Laney

Service Diagrams

DRAWN	D. E. H
DATE	18/07/95
TITLE	MIC INPUT CHANNEL
DRW. NO.	PCB 9028_5

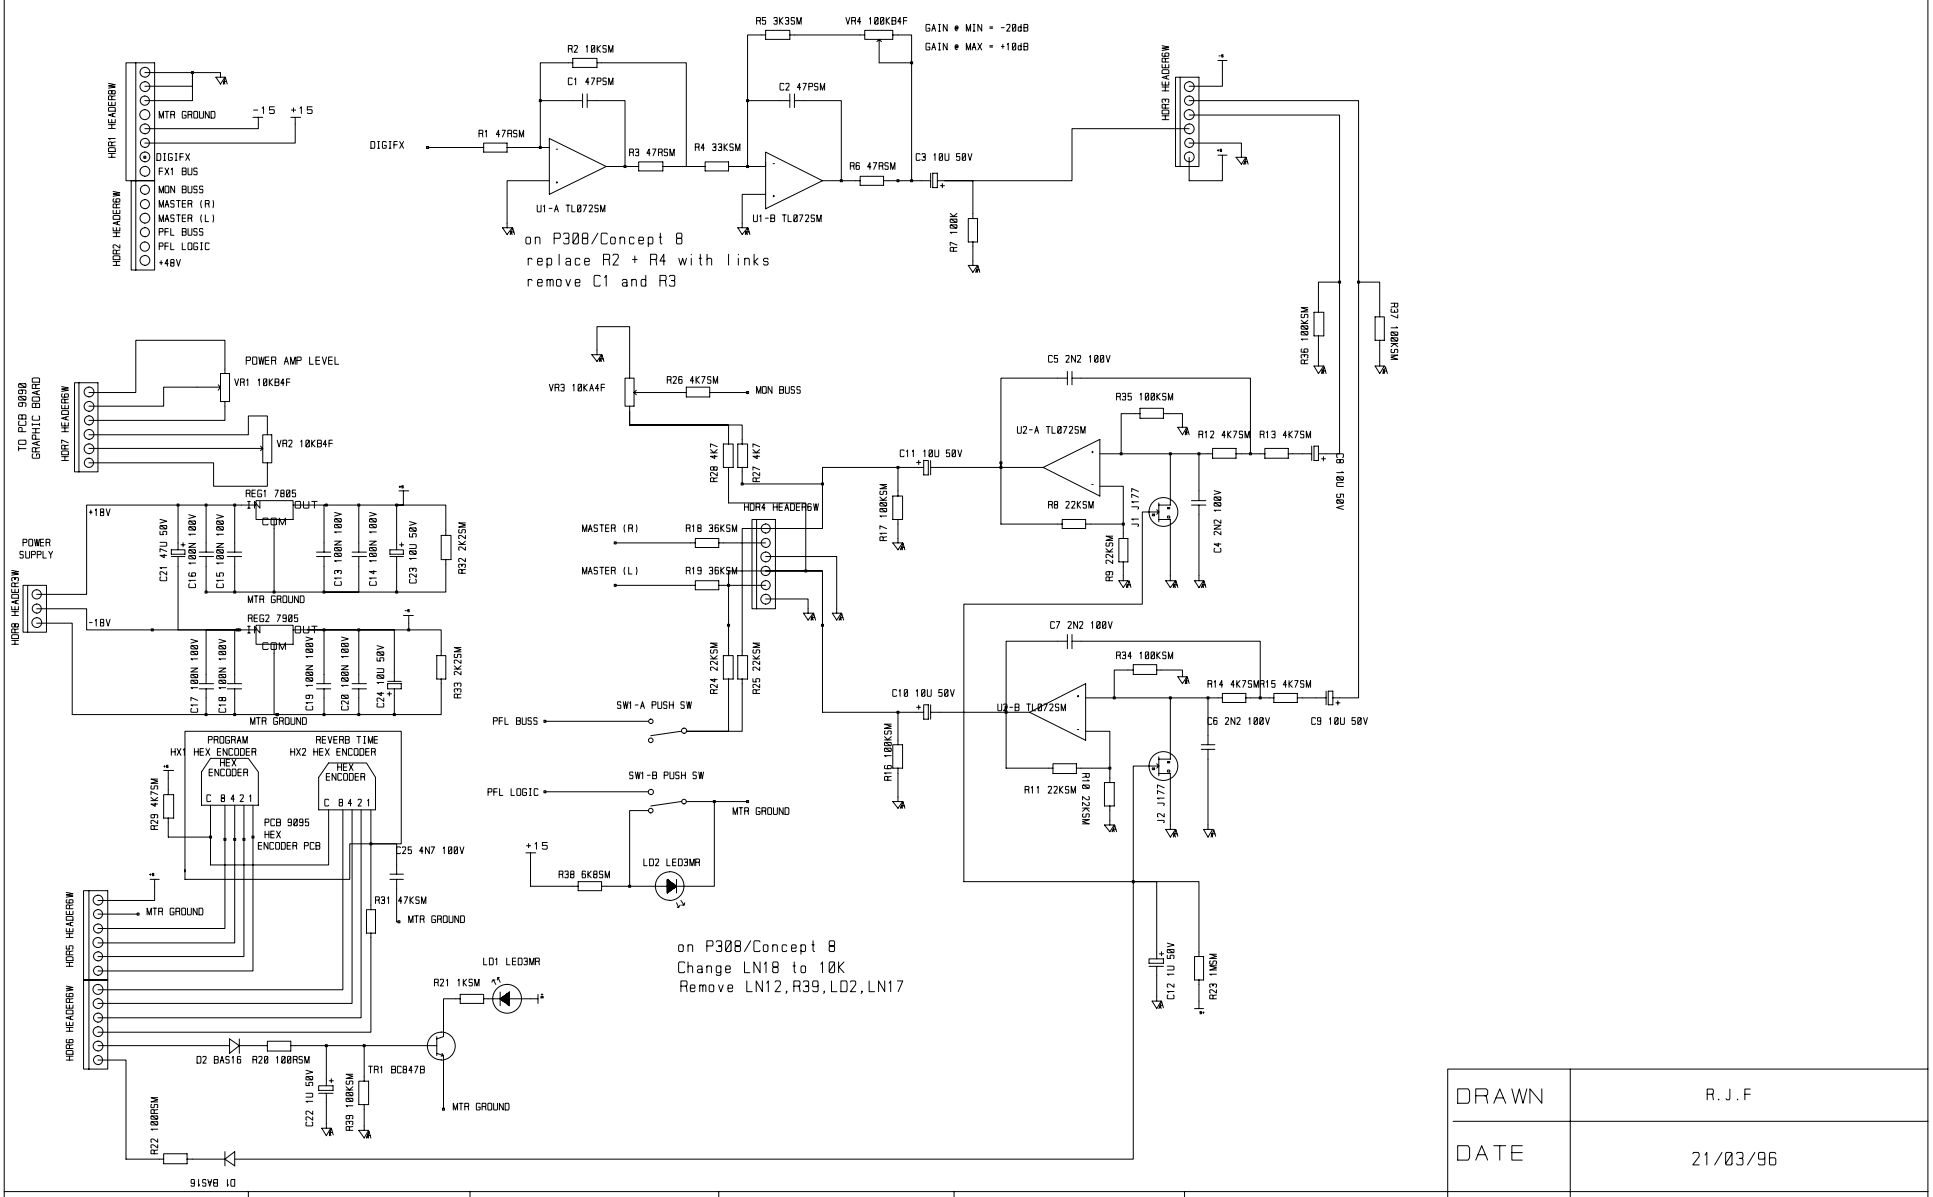
ISSUE	USED IN	USED IN	9028_5	17/07/96	9/5/97
TYPE	M1020R M1020S M1202SX	M16025X CONCEPT 6 CONCEPT 8	P308M	BOARD BEHIND INPUT XLR REMOVED FADER HEADER OPTION ADDED FOR THE CONNECTION OF AN EXTERNAL FADER	R16 to 47k from 4.7m Mic amp gain to +58dB R8 + R9 to 15k Increases Line input gain

DRAWN	R. J. F
DATE	07/06/95
TITLE	6 BAND STEREO GRAPHIC EQUALISER
DRW. NO.	PCB 9104

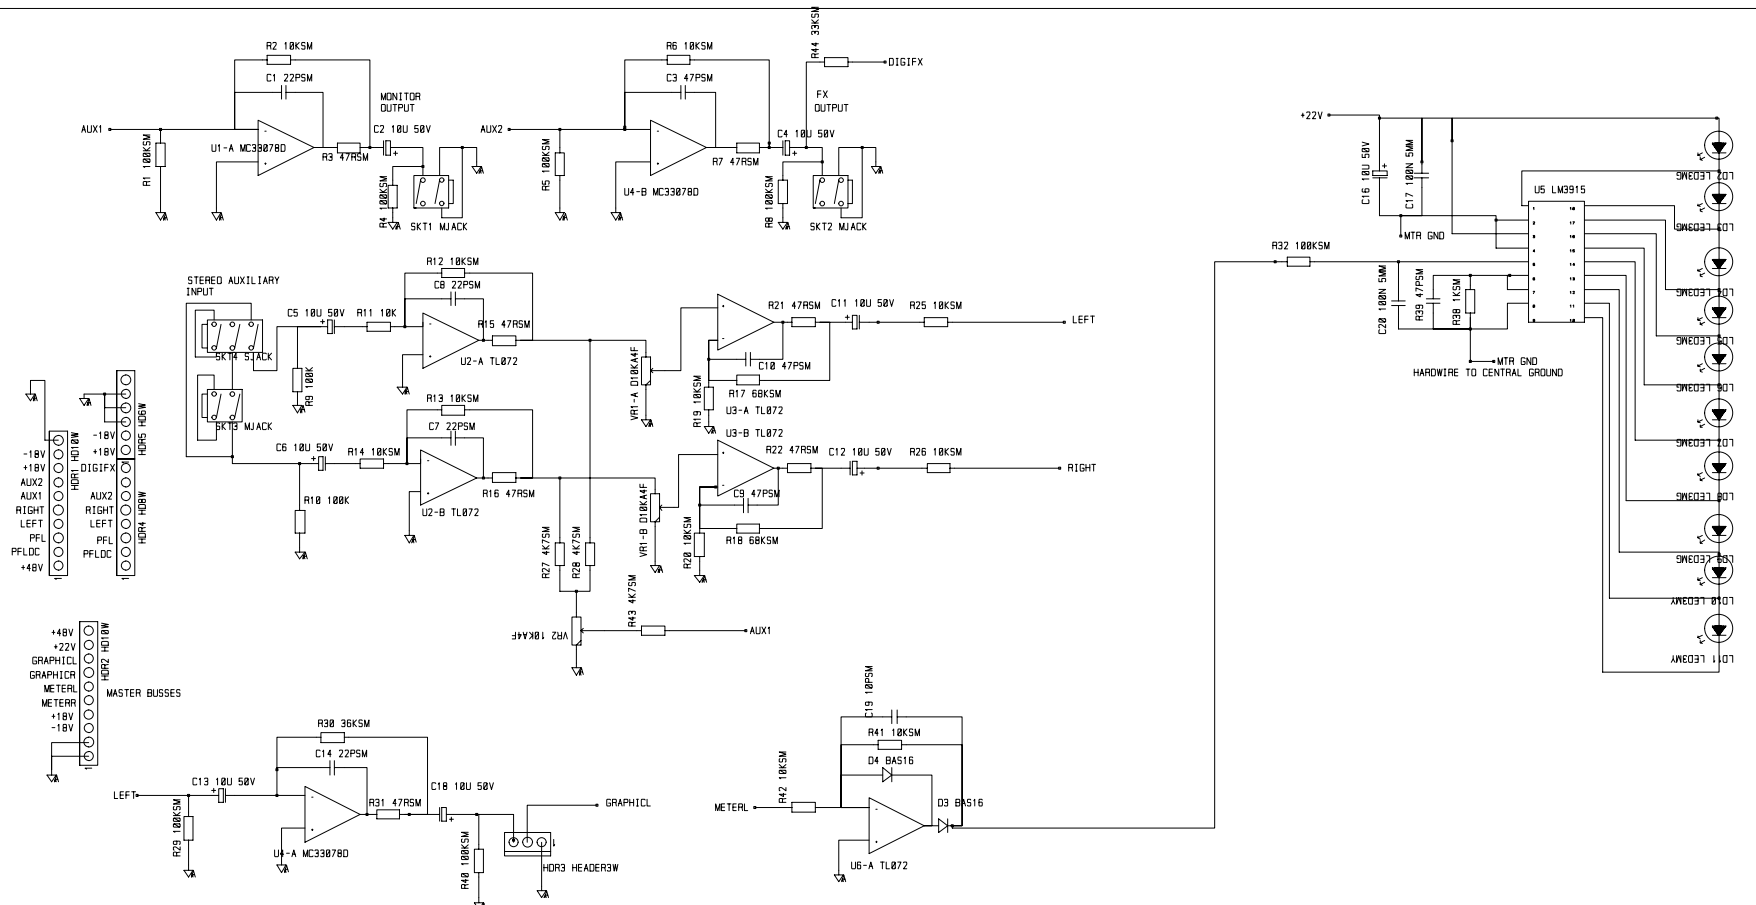
ISSUE	USED IN	18/03/97			
TYPE	CONCEPT 6 CONCEPT 8	P308M	FINAL INFORMATION ADDED

DRAWN	R. J. F
DATE	7/6/96
TITLE	MIXER LEFT MASTER
DRW. NO.	9105_2

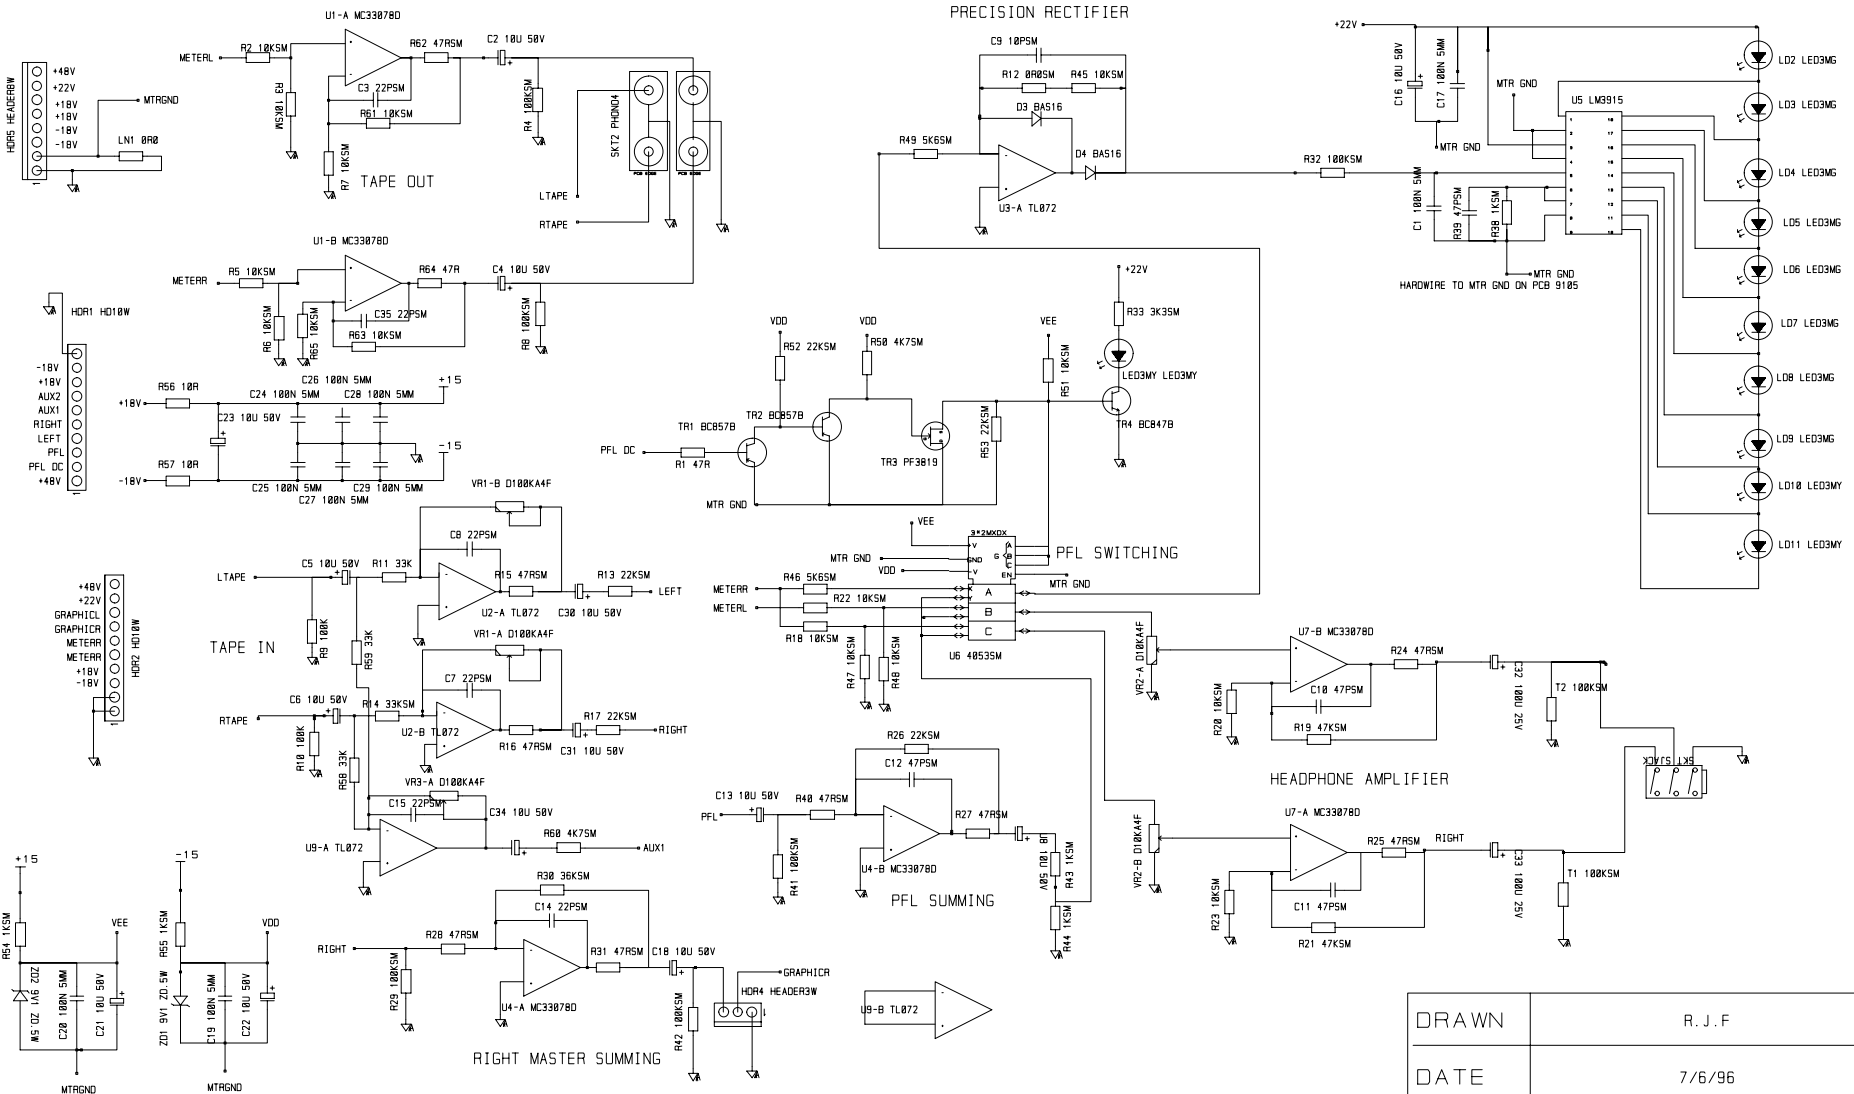
9087 COMPATIBILITY

AUX/DIGIFX BUS

AUX 1 OUTPUT SIGNAL IS ROUTED TO DIGIFX BOARD

U1-A NEEDS BYPASSING ON PCB9081 DIGIFX BOARD TO MAINTAIN CORRECT PHASING.

REPLACE R2 + R4 WITH LINKS

REMOVE R3 + C1

PFL LOGIC PCB 9087 CHANGES

LN18 CHANGE TO 10K

REMOVE LN12

REMOVE R39, LD2, LN17

ISSUE	USED IN	ISSUE TWO 11/09/96	ISSUE TWO		
TYPE	CONCEPT 6 CONCEPT 8	P308 CHANGED TO REFLECT ISSUE TWO MODS CHECK 9087 MODS PRIOR TO PRODUCTION	C1, C7-10, C14 to 22PSM

DRAWN	R. J. F.
DATE	7/6/96
TITLE	MIXER RIGHT MASTER
DRW. NO.	9106

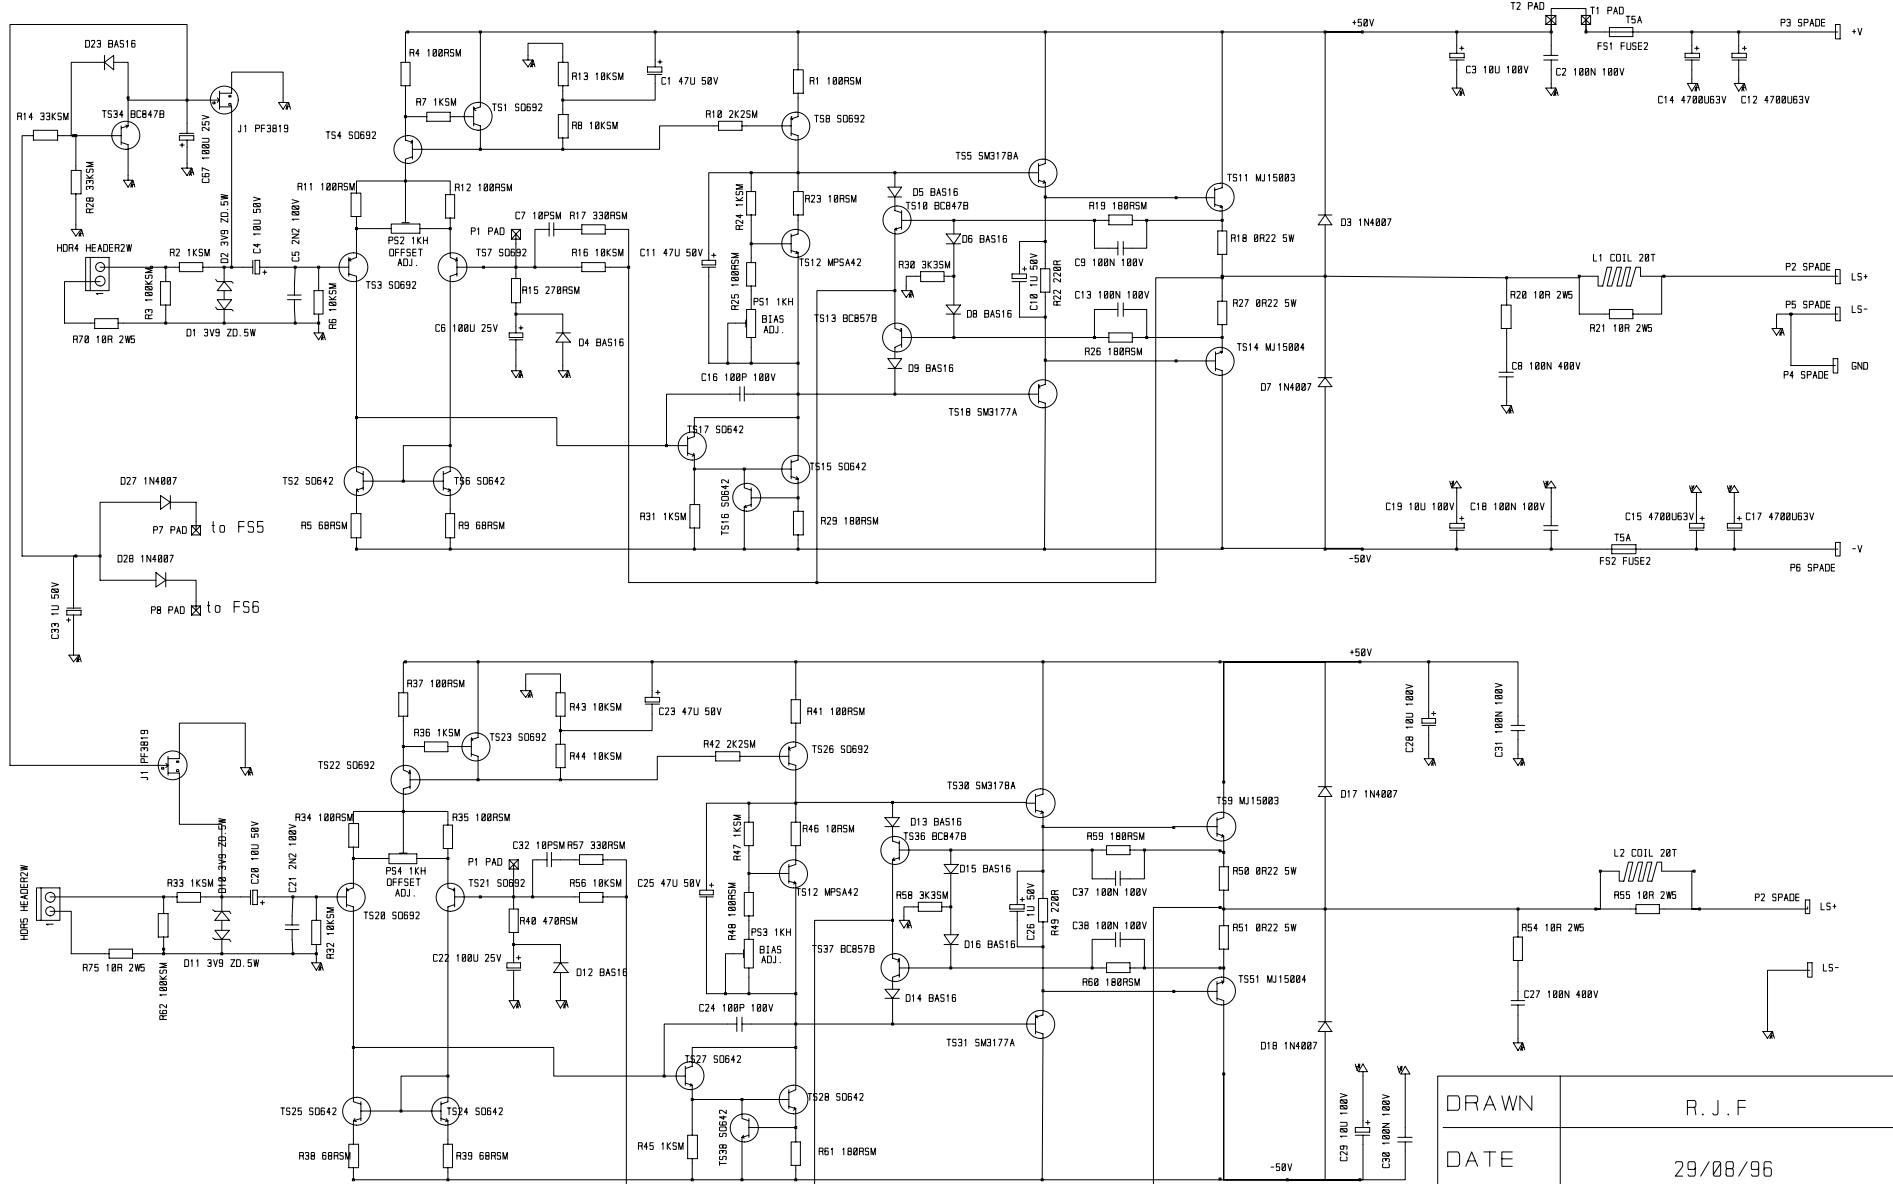
ISSUE	USED IN	ISSUE TWO 11/09/96	ISSUE TWO
TYPE	CONCEPT 6 CONCEPT 8	P308M	R26 to 22K C3, 7, 8, 14, 15, 35 TO 22pF
